Subject: Response to Public Comments Received on Re-submitted Human Health Risk Assessment Report – Offsite Soils Area.

Alliance 51st Street

Subject: Response to Public Comments Received on Remedial Investigation
Report and Cleanup Plan

**Subject: Summary Analysis of Groundwater Modeling
(Arcadis – Remedial Investigation – 1630-1640 51st Street)**

The above plume graphic with labeled isolines (contour lines) showing the predicted Chromium VI concentrations in mg/L. The white line marks the 0.1 mg/L PADEP threshold, while the black isolines provide a clear view of predicted concentration gradients across the site.

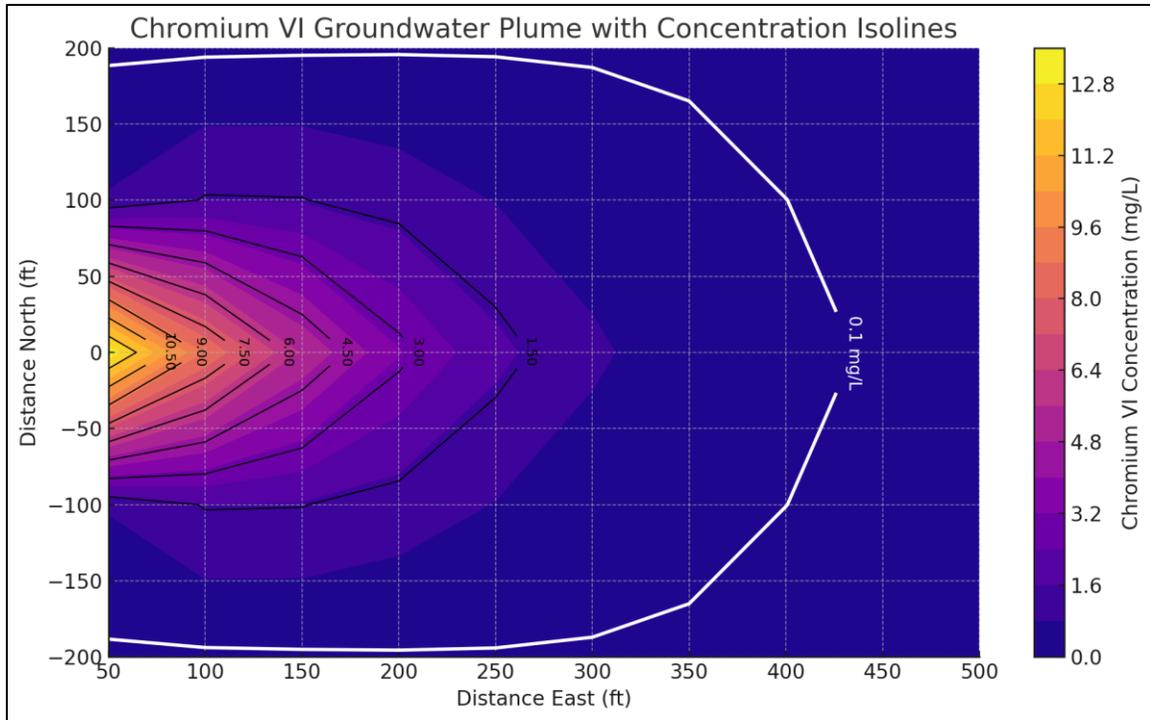
While Arcadis predicts how far the chemicals can travel east, it does not account for movement to the north or south.

That’s important because field data and QD model predictions show the contamination also spreads north and south, especially for hexavalent chromium, in addition to its eastward movement.

Arcadis’ assumption of one-directional flow along the groundwater path is helpful for showing general reach but may underestimate the true width of the contamination plume.

Although the model used by Arcadis includes the ability to show how contamination spreads in all directions, the report only explains how it moves to the east, in the same direction groundwater flows. This means it doesn’t fully explain that the contamination also spreads to the north and south, even though both the model and actual testing data show that it does. Focusing only on eastward movement leaves out important information about how wide the plume really is. To fully understand the situation and protect nearby areas like Bartram’s Garden, both the model results and the actual sampling data need to be looked at together when making cleanup decisions.

Response to Bartram's Garden Comment 1: The figures in the report related to fate and transport modeling are general schematics to simplify the interpretation of the model results. Groundwater beneath the Site and Bartram's Garden historically discharged eastward to the river, including when historic fill was placed in the area. People walking on the trails or visiting Bartram's Garden are not expected to contact groundwater as it is several feet below the ground surface. Groundwater is not used for potable purposes in the area and all residents and businesses are connected to public water supply. Future groundwater movement is not expected to require monitoring upon PADEP's acceptance of the Report and the modeling presented in the report, as well as the Final Report for the Site. See also Response to Bartram Garden's Comment 2.
